Access Compliance Report

Public Rights-of-Way

(Curb Ramps)

Intersection ID: 13595	Main Street: DEWBERRY_TR	Cross Street: DR_CARVER_RD	Location: SE
ADA ID: 722FAD7FAD27	Ramp Type: Perp	Initial Pass/Fail: Fail	Overall Compliance: No
Severity Score: 21.25			
Codes/Mitigation Info/Possible Solution		Field Measurements/Component Compliance

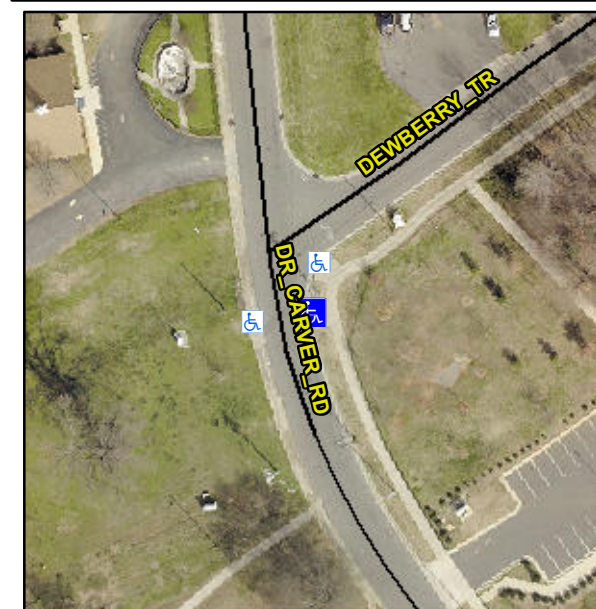
Not Found, R304.5.1, R304.5.3

Compliance	Description	Data	Compliance	Description	Data
N/A	Ramp Length (in)	96.0	Yes	Ramp Slope (%)	6.5
No	Ramp Width (in)	47.0	No	Ramp XSlope (%)	5.1
N/A	Flare Type LT	N/A	N/A	Flare Type RT	N/A
N/A	Flare Slope LT (%)	N/A	N/A	Flare Slope RT (%)	N/A
N/A	Flare Traversable LT?	N/A	N/A	Flare Traversable RT?	N/A
N/A	Landing Length (in)	N/A	N/A	DWS Provided?	N/A
N/A	Landing Width (in)	N/A	N/A	DWS Contrast?	N/A
N/A	Landing Slope (%)	N/A	N/A	DWS Length (in)	N/A
N/A	Landing X Slope (%)	N/A	N/A	DWS Full Width?	N/A
N/A	Landing Curb? (Y/N)	N/A	N/A	DWS Offset (in)	N/A
N/A	Shared Landing?	N/A			
N/A	Gutter Ponding?	N/A	N/A	Gutter Slope (%)	N/A
N/A	Gutter Lip Ht (in)	N/A	N/A	Gutter X Slope (%)	N/A
N/A	Painted X Walk1?	No	N/A	Painted X Walk2?	N/A
	X Walk 1 Direction	To W		X Walk 2 Direction	N/A
N/A	X Walk 1 Width (in)	N/A	N/A	X Walk 2 Width (in)	N/A
	X Walk 1 Slope (%)	5.6		X Walk 2 Slope (%)	N/A
	X Walk 1 X Slope (%)	3.9		X Walk 2 X Slope (%)	N/A

Remove & Replace Entire Ramp.
